Rosefield Solar Farm (EN010158)

**Rosefield Solar Farm – Buckinghamshire Council's Comments
to the Examining Authority's Written Questions 1**

Buckinghamshire Council

April 2026

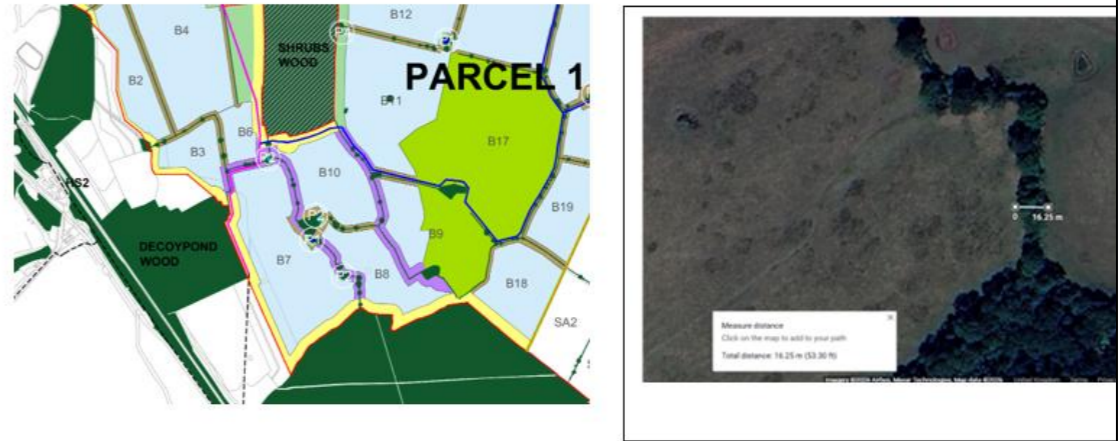
ExQ1	Question to:	Question	Buckinghamshire Council Response
			<p>and increased invertebrates available for bats to forage. While the research to date has considered cattle grazing, the relationship with sheep has not been investigated. The technical study has attempted to compare the insect communities associated with sheep and cattle, but has only considered this at a high level; that sheep dung also attracts flies and moths, rather than considering the species assemblages associated with cattle vs sheep.</p> <p>The additional information has not addressed the council's concerns that solar farms may be displacing bats for reasons which are not yet understood. The placement of panels in these fields therefore could make them unsuitable for bats to forage, even if livestock are present.</p> <p>The technical study has also attempted to compare the numbers of bats using boundary features with the numbers using the open fields, concluding that there are more bats using boundary features than the open fields, asserting that the open fields are therefore not important for Bechstein's bat at this site. There is a significant issue in the methodology in that only one detector was placed within the open fields. Detectors can only detect bats that come within close range; often within approximately 5m), whilst this method of detection works well along a boundary feature; as bats will mostly fly within close proximity to the detector when following a boundary, it doesn't work for a large open area where the bats could be using space not in close proximity to the detector. Whilst this has been mentioned as a limitation within the study, it has been overlooked when conclusions have been drawn. The council therefore does not consider that this study is suitable to inform decision making and instead refers to previous evidence^{3,4} which indicates Bechstein's bats do forage in open fields and in particular pasture grazed by cattle.</p> <p>2. The methodology used to measure proposed buffers for hedgerows and woodland.</p> <p>The proposed buffers for hedgerows and woodland are being incorrectly measured from the centre point of each hedgerow. The applicant has stated the reason for this is to provide consistency across the site. While this could be acceptable for 'standard width' hedgerows (e.g. 3m width stated by Natural England), there are several existing hedgerows in the site that have widths in excess of 3m stated by Natural England. Examples of these include the corridors around fields B7, B8 & B10 which comprise important links to existing woodlands: Sheephouse Wood, Decoy Pond Wood and Shrubs Wood. The hedgerow linking these woodlands exceeds 16m in width in many sections. Taking the central point of hedges this wide to calculate the buffer is not considered proportionate or acceptable. The map below from Appendix 2.A of the LEMP [REP1-086] shows the purple mitigation corridor for bats alongside aerial</p>

imagery with measurements south of pond P2. The applicant needs to review hedgerows across the site to ensure appropriate buffers are established at the thresholds they have agreed.

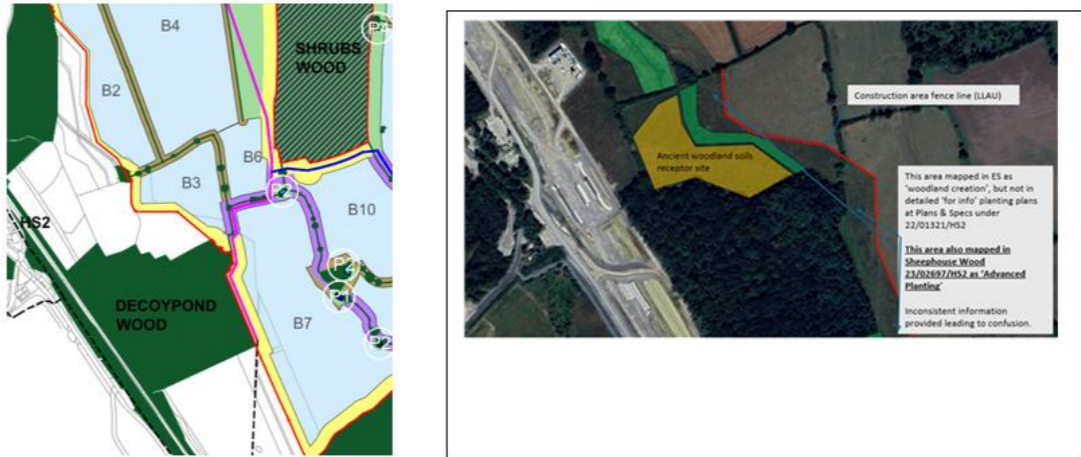
Field B3 will also need to be re-assessed as it currently shows solar array in areas where existing HS2 buffer planting has already occurred. A buffer of the same scale to those described (i.e. 30m) will also be required at this section as illustrated below
